J. H. FLETCHER & CO. Box 2187 – Huntington, WV 25722-2187 – 304/525-7811 – FAX 304/525-4025

INFORMATION BULLETIN NO. 107

TO:	<b>OWNERS OF THE HDDR/CHDDR ROOF DRILL</b>
FROM:	<b>RISK MANAGEMENT DEPARTMENT J.H. FLETCHER &amp; CO.</b>
DATE:	<b>JANUARY 2008</b>
SUBJECT:	<b>(C)HDDR OPERATOR DRILL STATION SAFETY ENHANCEMENTS</b>

# CANOPY EXTENSION

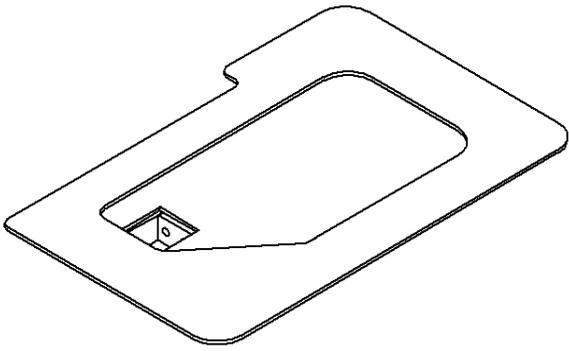
First: Fletcher has increased the size of the HDDR drill canopy (see Illustration 1). This new design adds up to 4" to the existing canopy inby towards the ATRS. The enlarged canopy provides additional coverage outby and towards the rib as well. Clearance

between the canopy and drill mast is reduced and must be evaluated to determine if this is a feasible option. Additionally, if your machine has an "L" style ATRS you may not be able to utilize this enlarged canopy.

# ROCKER PAD ASSEMBLY

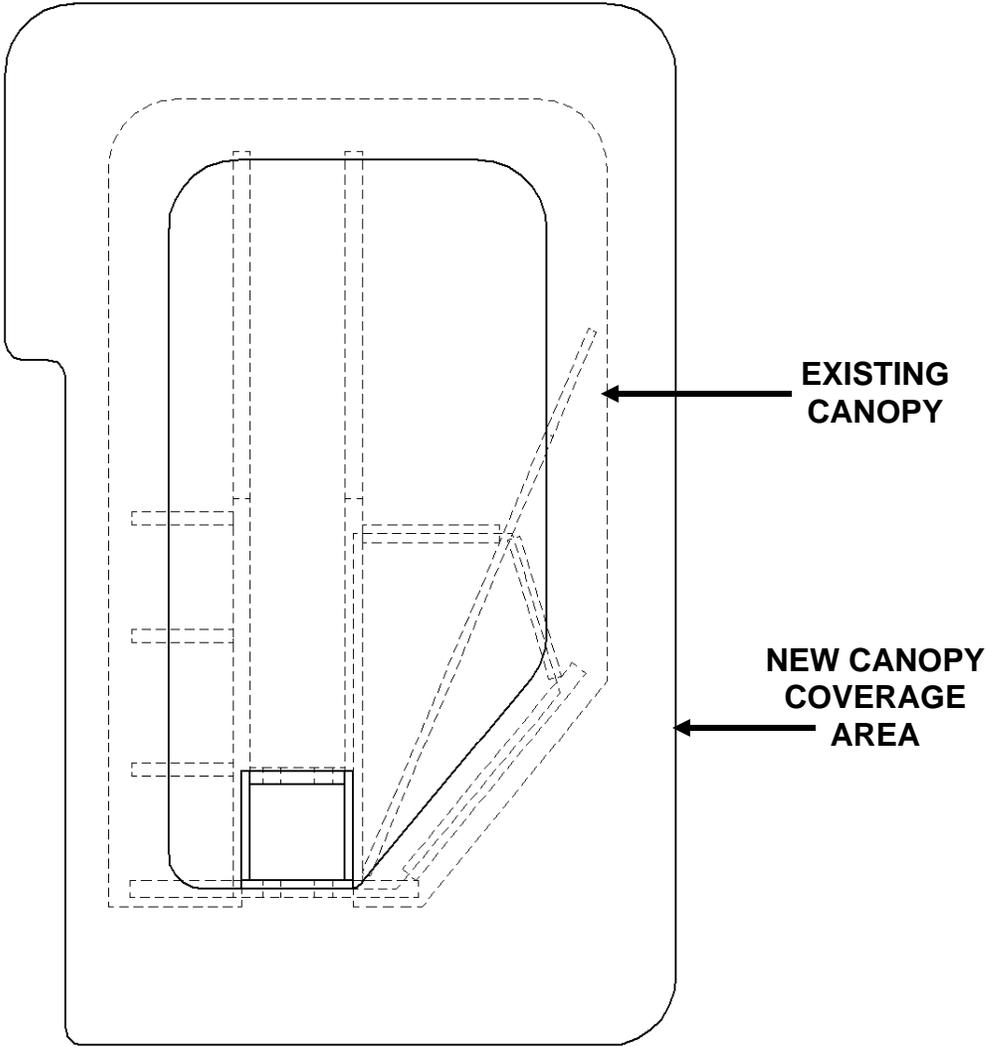
Second: Fletcher can provide a rocker pad with an outby extension for your TRS beam (see Illustration 2). The extension helps to reduce the gap between the outby edge of the ATRS rocker pad and the center of the drill head. The extension reduces clearance between the mast and ATRS. There is a risk that the extension could become fouled with other components or parts. Close attention and observation by the operator is essential when extensions are used. Damage to the mast or ATRS could occur.

# RIB SHIELD

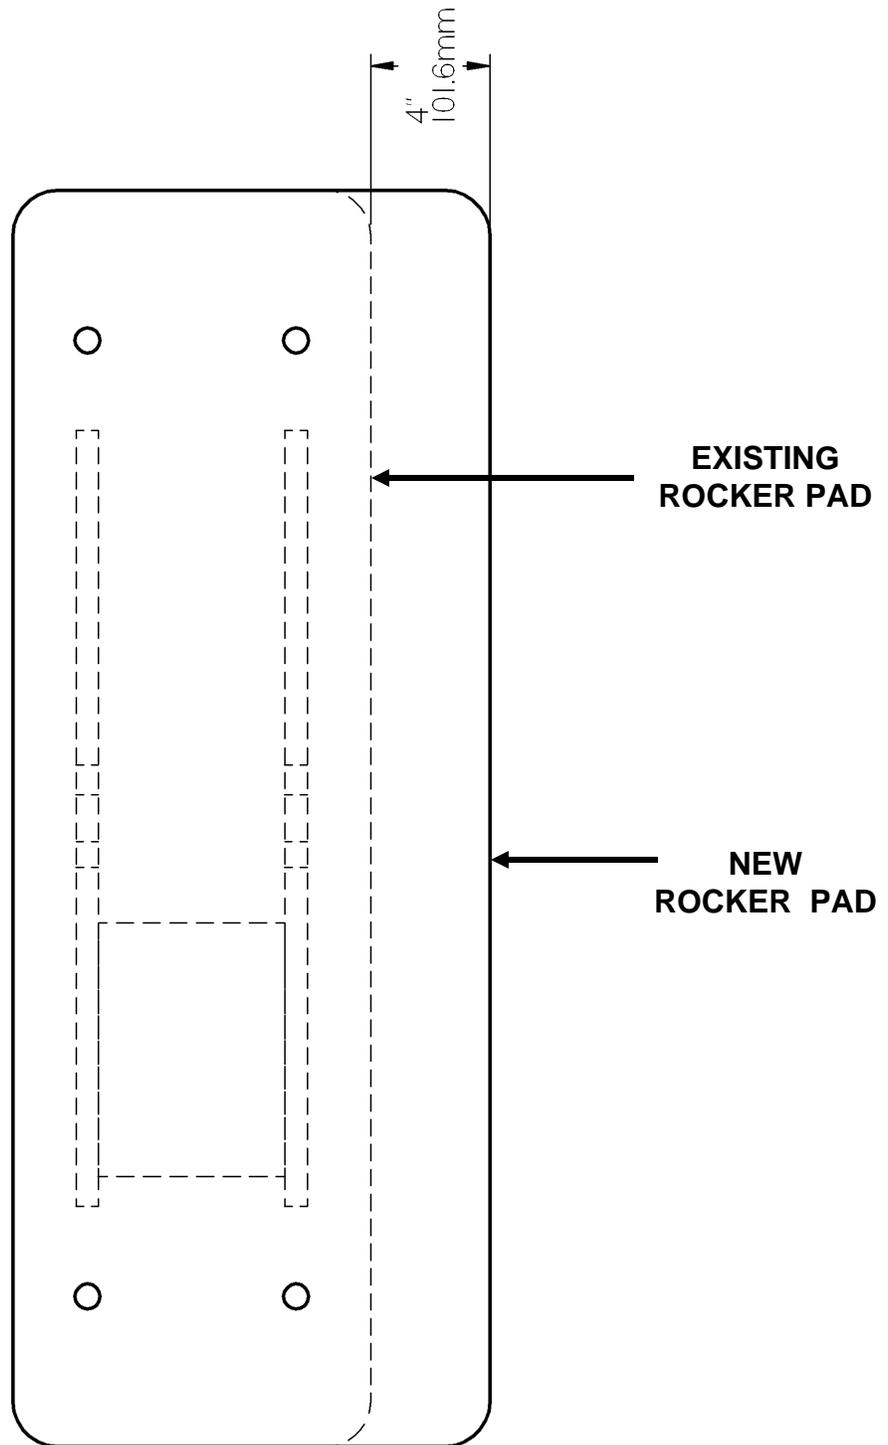
Third: Fletcher developed a rib shield for each drill boom operator (see Illustration 3). The rib shield attaches to the canopy to provide lateral protection from small rocks that might enter the drill control station. The addition of this component will reduce the collapsed height of the drill canopy.
